# NEWMAR CORPORATION WARRANTY DEPARTMENT

## RECALL SERVICE BULLETIN

DATE ISSUED	MODEL YEAR(S) AFFECTED	RSB #
10/14/2016	2015-2017	463

## How to Add the Ignition Lock Out Feature to a Power Wheelchair Door

## Relay Removal, Modification, and Re-installation

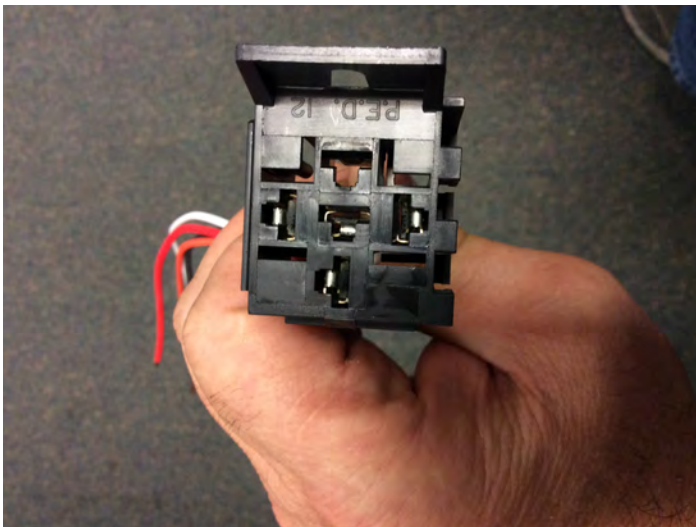
1. Modify the relay harness by removing the 87a relay.
2. Move the brown wire from the 87 "normally open" position to the 87a "normally closed" position.

3. Release the brown wire terminal using a terminal tool, small blade screwdriver, or a paper clip. Make sure the clip on the terminal holds the brown wire securely in the new location, and bend the tab out if necessary.
4. Then re-install the relay.

## Relay Harness Preparation

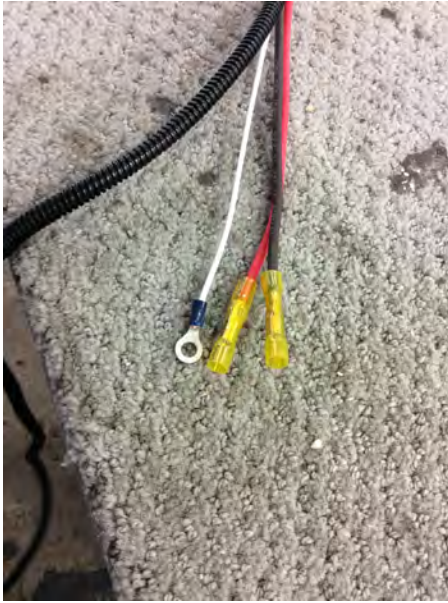
5. Prepare the relay before starting install by stripping all four wires back about 3/8".
6. Crimp the yellow butt connectors to the red and brown wires.

7. Crimp the blue ring terminal to the white wire.
8. Then crimp the four foot orange wire to the orange relay wire using the red butt connector.
9. Add the 3/8" loom to orange wire only.

### Relay Harness Installation

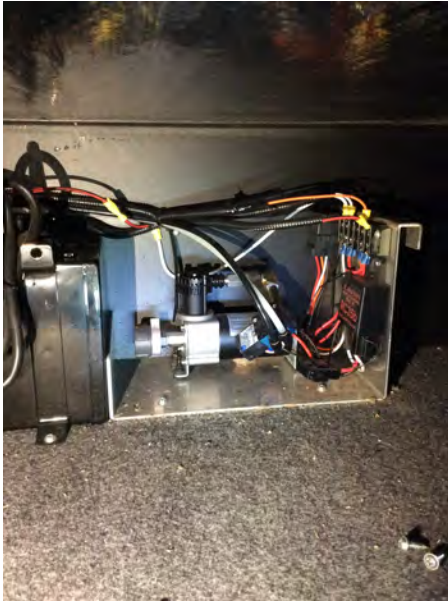
10. Remove the cover around the door control.

11. Locate the main red power feed wire, and trace back several inches until you locate the yellow butt connector.

12. Cut the wire on both sides of the butt connector.

13. Strip the wires.

14. Connect the relay's red wire to the power (feed) side of the wire using a yellow butt connector.

15. Connect the brown relay wire to the red wire where the yellow butt connector was removed on the terminal block side.

16. Locate the pink wire with a green stripe connecting to the slideout modules nearby.

17. Trace the wire back in loom to find a convenient spot to connect the orange wire from the relay.

18. Modify the length of the orange wire (if necessary), depending on where you can attach it to the pink wire with the green stripe.

19. Cut the pink and green wire, and strip both ends.

20. Use a yellow to blue butt connector to attach the orange wire to the pink and green wires.

21. Crimp two wires in the yellow side and one wire in the blue side.

22. Strap the orange wire with loom if necessary.

23. Remove the white ground wire to the ground at the steel frame by removing the existing screw.

24. Install the new white ground wire from the relay with the existing ground wire by reinstalling screw with star washer against steel frame.

### Testing for Proper Operation

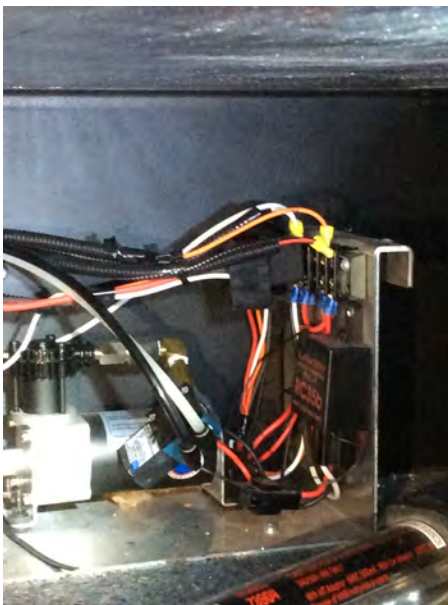
25. Test the operation of the power door and key fob with the key in the off position. Make sure it works.

26. Test the operation of the power door and key fob with the key in the run position. Make sure it does not work.

27. Use a wire tie to secure the relay to the wiring.

28. Reinstall the cover around the door control.
